Addendum #	02	Date Issued	03/31/2025
Project Name Job #	SWN 0509, Waneta Hall Renovate Restrooms	OSE # R0325--15X	EAPC #20256780
Bid Date Time	April 3, 2025		3:30pm

THIS ADDENDUM AMENDS AND BECOMES PART OF THE CONTRACT DOCUMENTS FOR EAPC PROJECT 20246780 DATED 03/13/2025, RESPECTIVELY. EACH BIDDER SHALL ACKNOWLEDGE RECEIPT OF THIS ADDENDUM BY MARKING THE ADDENDUM NUMBER AND DATE ON THE BID FORM.

DRAWING TITLE
REFLECTED CEILING PLAN - ADD ALTERNATES

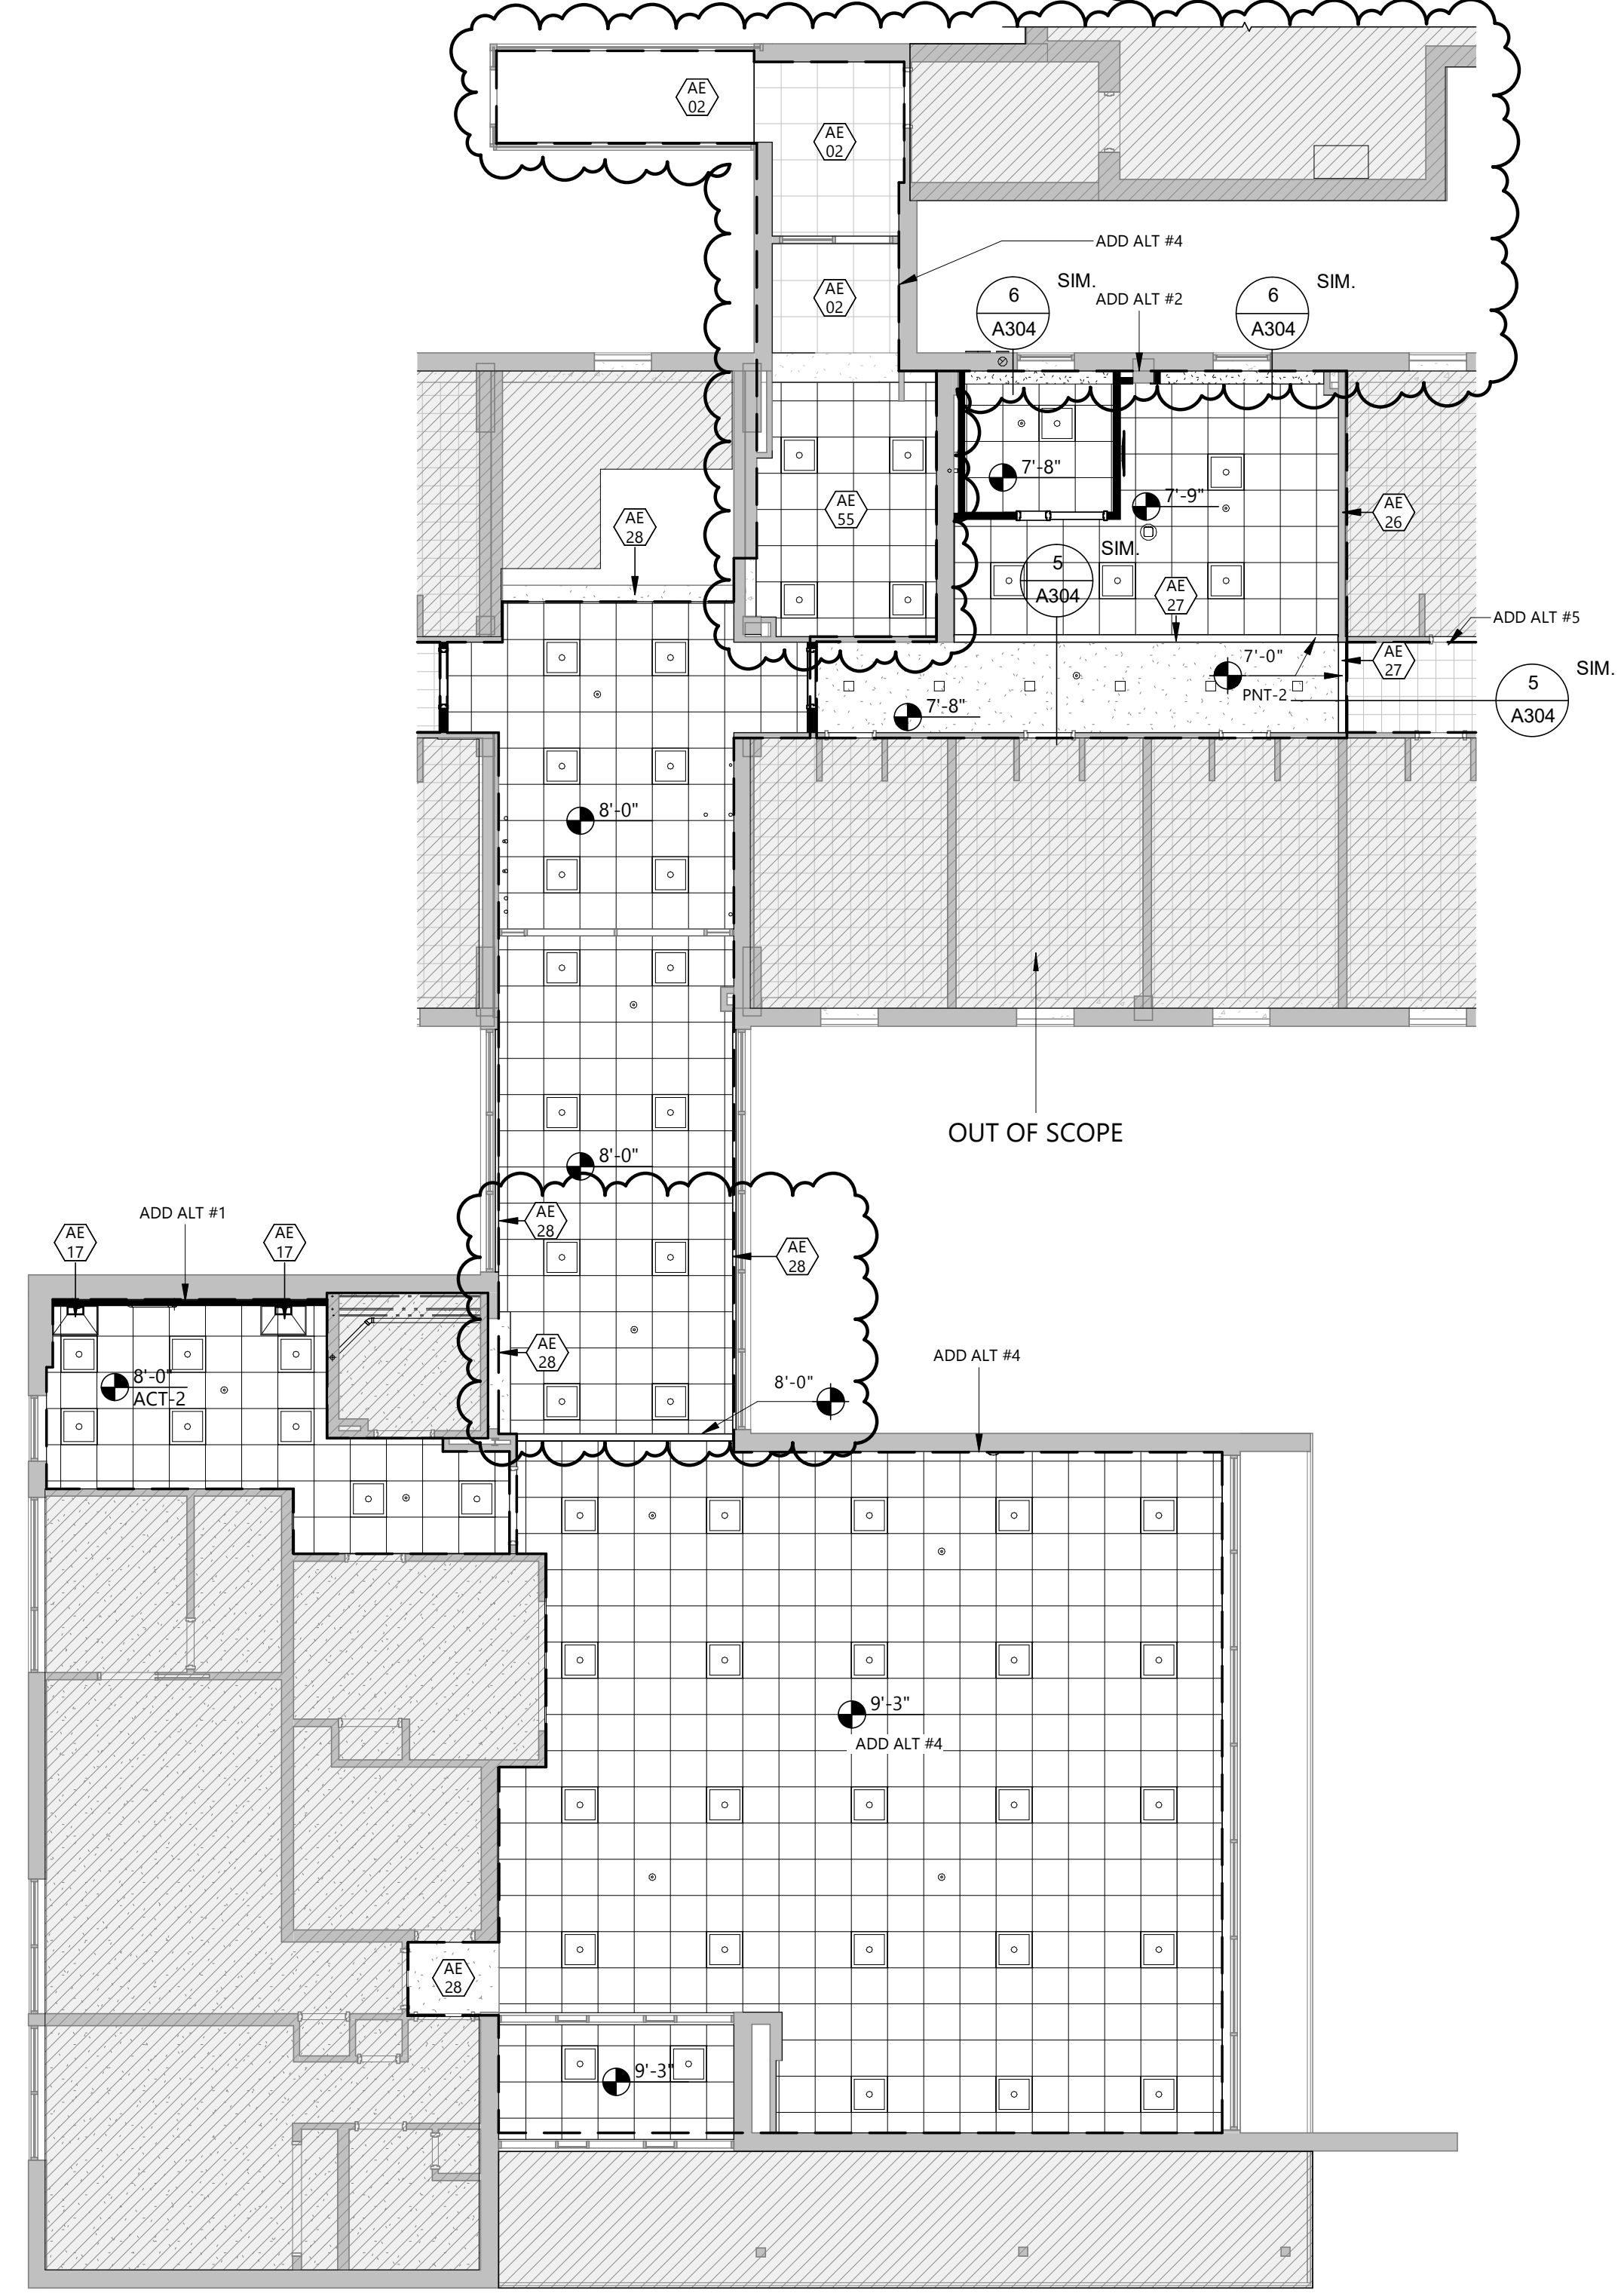
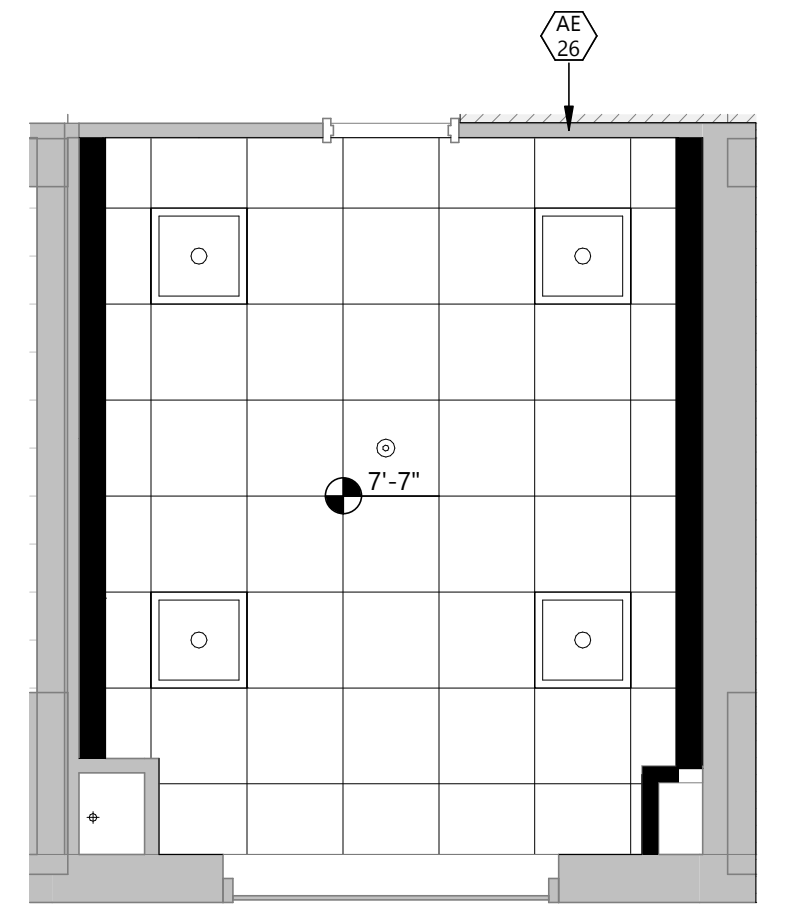
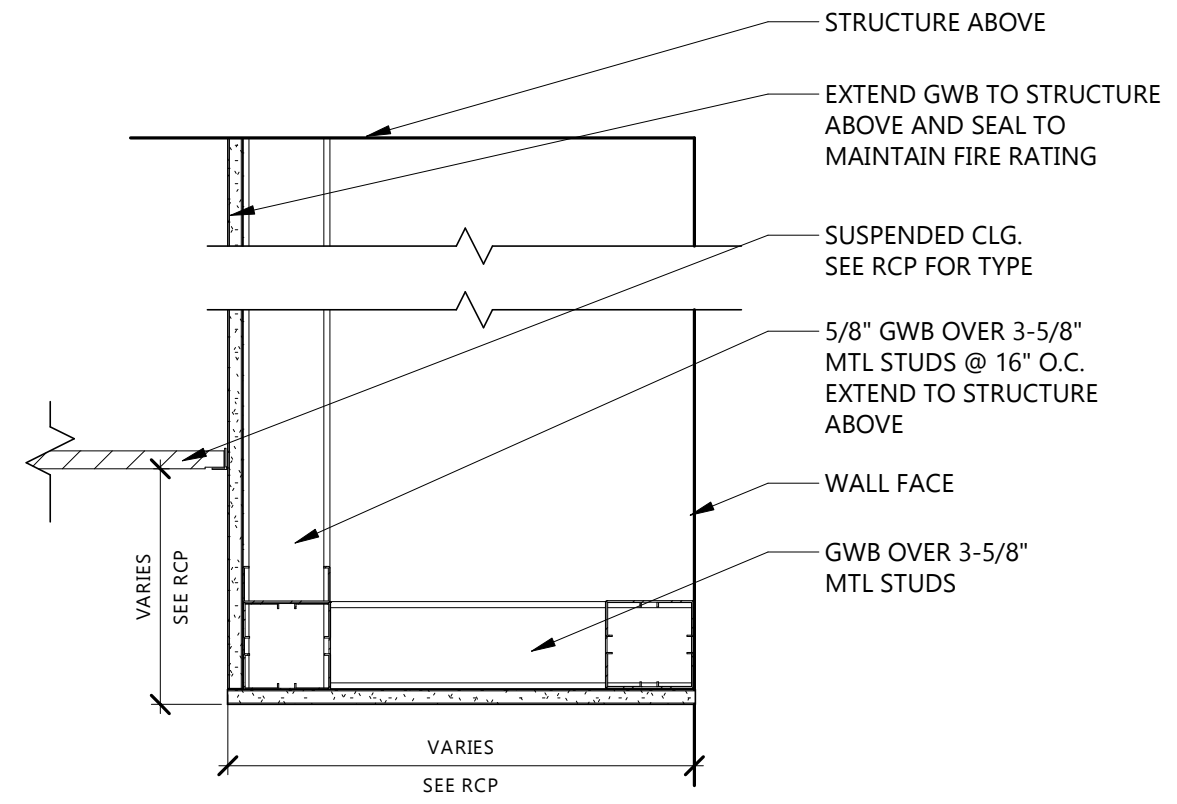
A101	REMOVE Keynote AD 17 at WOMEN 127 and MEN 177 REVISE Keynote AE 33.
A200	ADD Keynote AE 56 and REVISE AE 35 in Keynote Legend.
A221	ADD Keynote AE 57.
A304	REVISE ceiling layout on 1/A304. ADD Keynote AE 55 and REVISE AE 28 in Keynote Legend.

14 **POD ADA - TOILET ACCESSORIES**
A701 1/4" = 1'-0"

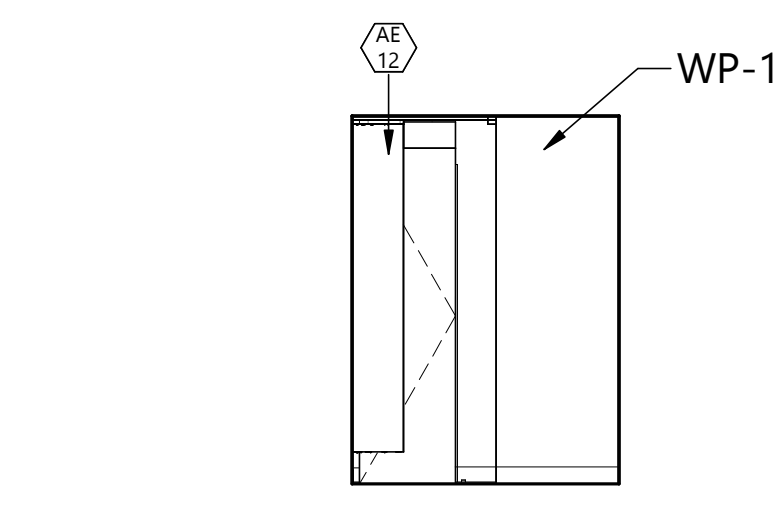
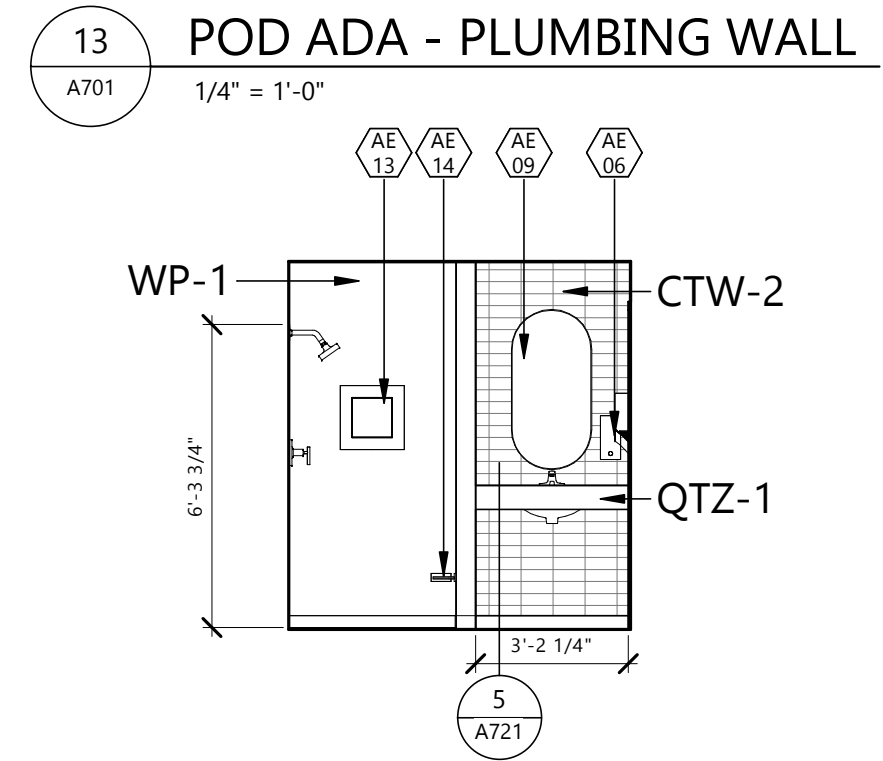
- A701 REVERSE Bottle filler tile to CTW-3.
CLARIFY tile extents and integral base at 14/A701.
CLARIFY extents of integral base at details 1, 2, and 3.
REMOVE Keynote AE 37 and ADD AE 11 at detail 17/A701.

7 WATER FOUNTAIN - LOBBY (ALT 04)
 A702 1/4" = 1'-0"

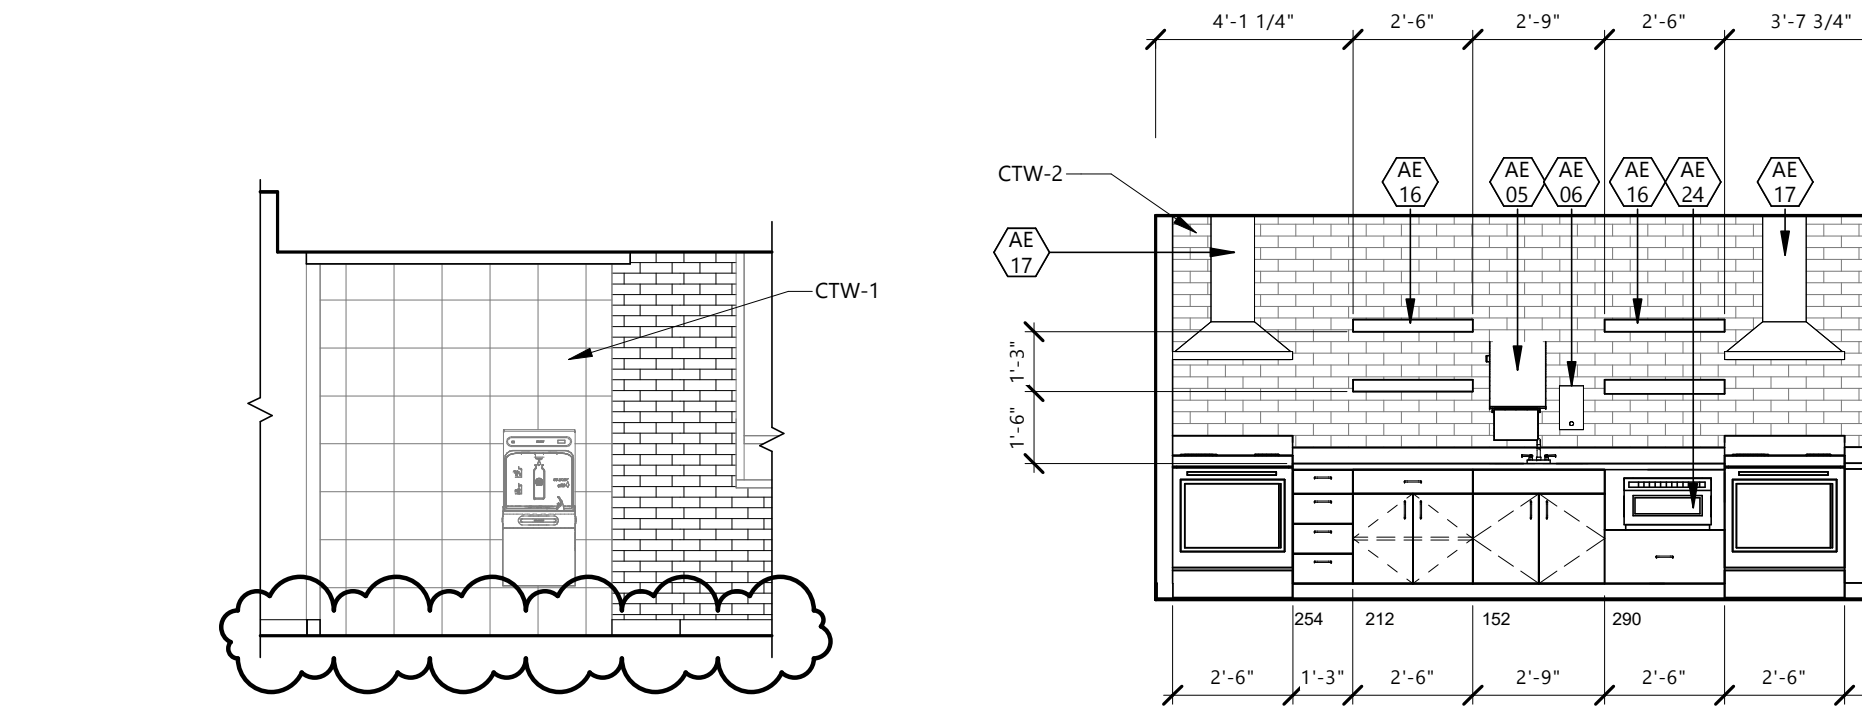
- A702 REVERSE tile extents at 7/A702.
- A901 REVERSE Keynote AI 03.
REVERSE CTW-1 to CTW-2.
CLARIFY paint finishes at General Finish Notes 5,17,19, and 22.
